**Federal Aviation
Administration**

Updated Response to
Oakland Airport-Community
Noise Management Forum's Recommendations

August, 2018

Figure 1 - Comparison of SILENT (orange) and HUSSH (green) ground tracks.
NOTE – Tracks not assigned these SIDs have been removed for clarity.

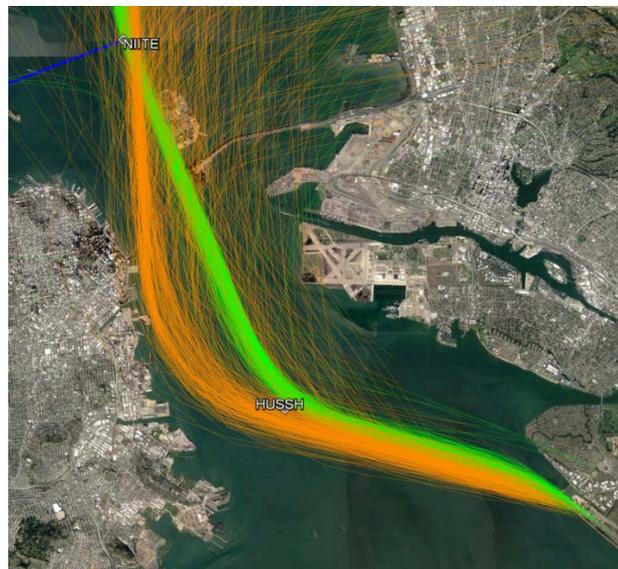
- 1.1 "The short-term solution would be for Air Traffic Control to assign headings to aircraft departing OAK runway 30 that restore the initial SILENT ground track."

Explanation: The FAA cannot support this recommendation for the following reasons. The SILENT Standard Instrument Departure (SID) is a conventional procedure that uses ground-based navigation. While the SILENT SID is still a published procedure, it has largely been replaced by the HUSSH SID, which is an RNAV procedure that uses satellite-based navigation and provides much greater precision. The OAK Noise Forum's recommendation to restore the conventional SILENT SID ground track may provide minor relief from noise concerns on the east side of the Bay, but a return to the SILENT SID ground track will create significant noise concerns for the San Francisco area. As illustrated in Figure 1 below, the HUSSH SID (green) is generally in the middle of the Bay until the REBAS waypoint (not pictured). The SILENT SID (orange), however, averages within 0.5 NM of downtown San Francisco.

Figure 3 – For clarity, only the TIPRE / SYRAH transitions to TAMMM are shown, as well as tracks for those transitions.

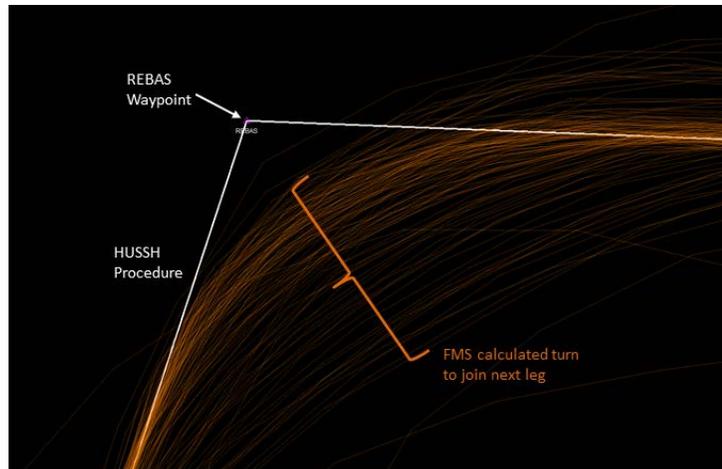
1.3 “...evaluate the HUSSH procedure and adjust it to replicate the SILENT SID ground track and require aircraft to fly to REBAS unless safety dictates otherwise and adjust the REBAS intersection offshore to keep aircraft over the water instead of turns over land.”

The FAA cannot support this recommendation for the following reasons. Moving the REBAS waypoint west of its current location would jeopardize safety because it removes the requisite separation. As illustrated in Figure 3 (below), the REBAS waypoint is a fly-by waypoint, meaning aircraft are not required to overfly the waypoint. Rather, the aircraft’s Flight Management Software (FMS) will calculate when to start its turn prior to REBAS (based upon weather, aircraft performance, weight, etc.) so the aircraft smoothly joins the next leg of its route.

Figure 6 - HUSSH procedure (White) and HUSSH departure tracks (Orange), illustrating FMS calculated turn.

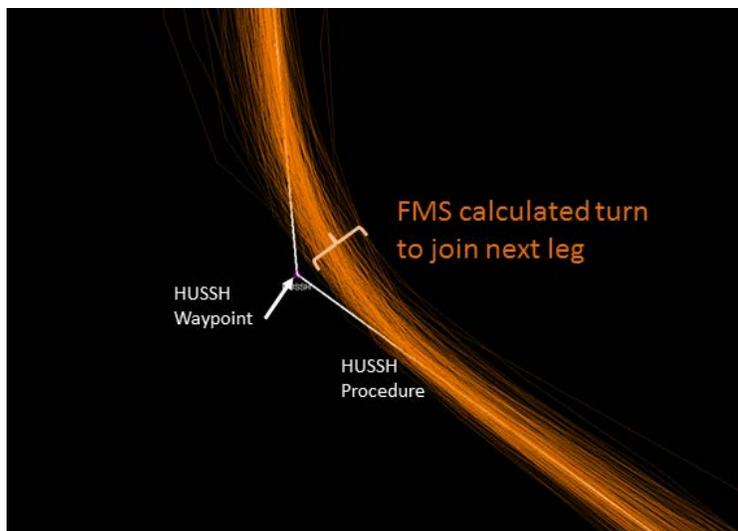
1.4 “...moving HUSSH waypoint southward as much as feasible to facilitate a sharper left turn by aircraft after departing OAK runway 30”

Part of the ability for aircraft to remain this close to the route centerline(s) is the calculation of the turn from one segment to another. Current procedure design criteria preclude the use of “fly-over” waypoints in lieu of “fly-by” waypoints without an identified operational/safety advantage. As such, for turns similar to that of the HUSSH waypoint on the HUSSH SID, the aircraft does not actually pass over the waypoint. Rather, each aircraft’s flight management system calculates the most effective turn that will balance the amount of time that the aircraft is not over a route centerline but is still

within aircraft/airline flight profile limits. Generally speaking, the more acute the angle is between two route segments, the greater the divergence will be from the waypoint. This is illustrated in Figure 6; the segment angle at HUSSH is 130°.

This characteristic of RNAV SID procedures would preclude any benefit to the modification of the HUSSH waypoint. By moving the waypoint to the south, the turn required to join the next segment to NIITE would not have a noticeable impact to the flight tracks over the ground.

Figure 9 – CNDEL SID (tracks in green, procedure in yellow) and SSTIK SID (tracks in magenta, procedure in blue).

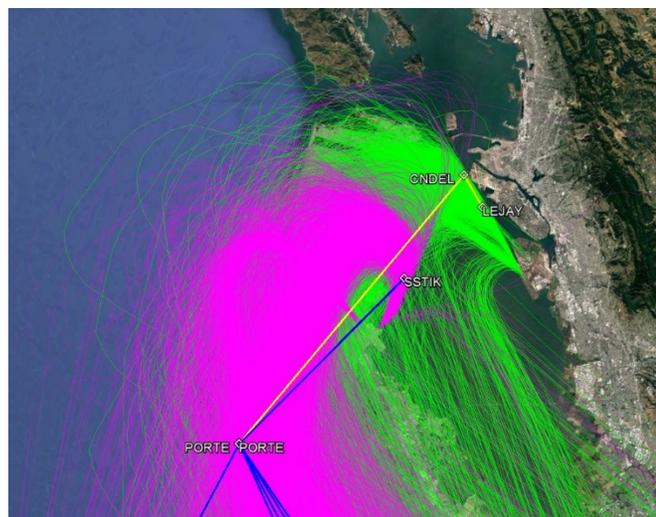
- 4.1 “Consider adjusting CNDEL THREE departure so that the ground track for this departure is further away from BFI/Alameda. This could be accomplished by directing aircraft departing OAK runway 30 to turn left to a heading of 280° until reaching the OAK 4 DME arc.”

Explanation: The FAA cannot support this recommendation for the following reasons. The geographical relationship between SFO and OAK flight operations precludes the amendment of one procedure without affecting another. One example of this, as illustrated in Figure 9 (below) is the SSTIK SID from SFO and its impact on OAK departures. Similar to the HUSSH and SILENT SIDs, an assignment of a 280° heading for CNDEL departure aircraft does not ensure the required separation will be maintained with aircraft on the SSTIK SID.

Similar to the issues caused by the recommended changes to the HUSSH SID (please refer to OAK Noise Forum Recommendation 1.1 for more information), an initial heading of 280° for OAK departures would provide minimal benefit to the area of BFI/Alameda. As stated previously, the increase in delays caused by a mandatory heading such as this would be severe; a 280° heading would remove lateral separation provided by the procedures and in order to ensure safety would require the individual coordination of CNDEL departures from OAK, which would impose major delays for both SFO and OAK airports.

Figure 10 - SFO TRUKN Departures from runway 01.
Average altitude at TRUKN waypoint (indicated by black arrow) – 5,176' MSL.

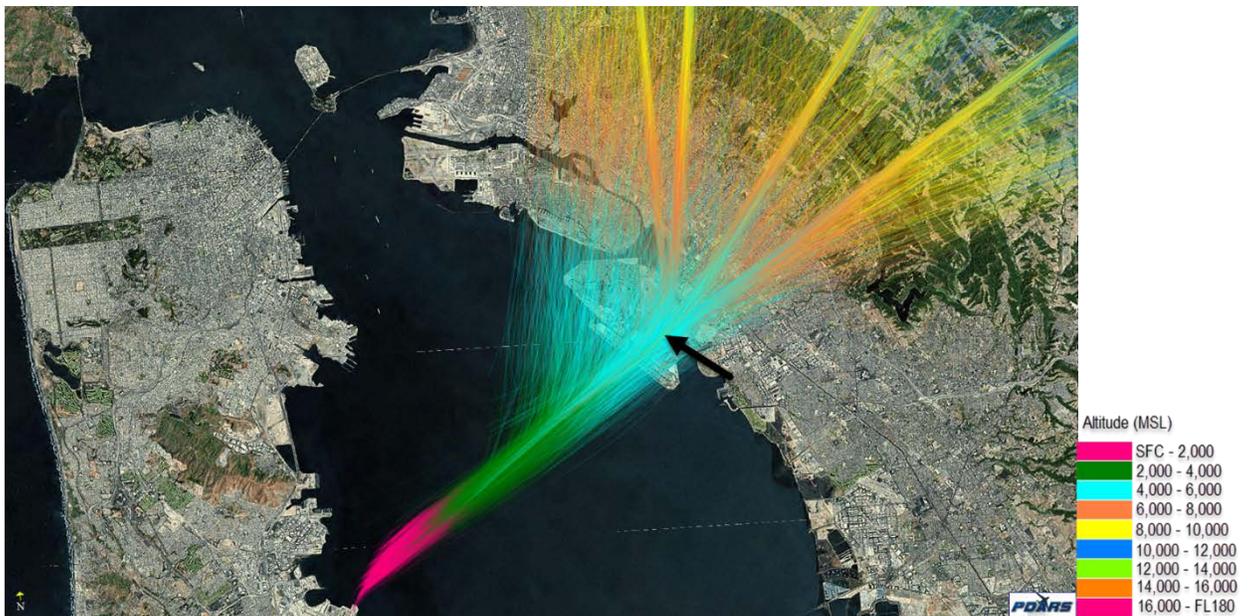
- 6.5 “... the FAA investigate for both TRUKN North and TRUKN East: Analyze if a procedural decrease in altitude over TRUKN exists and whether higher altitudes can be restored.”**

Explanation: The FAA cannot support this recommendation for the following reasons. Departure runway, meteorological conditions, pilot/aircraft operating practices and other factors can affect the overall altitude of an aircraft; however, FAA investigations have determined that no procedural changes have been made that would account for a change in aircraft altitude. For example, preliminary initial flight track analysis of July of 2014 and of 2017 appear to reflect that although the tracks are slightly lower, the changes in altitude

Another consideration is altitude restriction. If altitude restrictions were added to the TRUKN departure procedure to increase the climb gradient (increase in altitude over a set distance over the ground), the highest crossing restriction that could be applied at TRUKN waypoint would be at or above 4,530 ft. MSL. Based on preliminary feasibility focusing on flight procedures criteria and overall fly-ability, the average altitude of flight tracks (from runway 01 at SFO) was 5,176 ft. MSL.
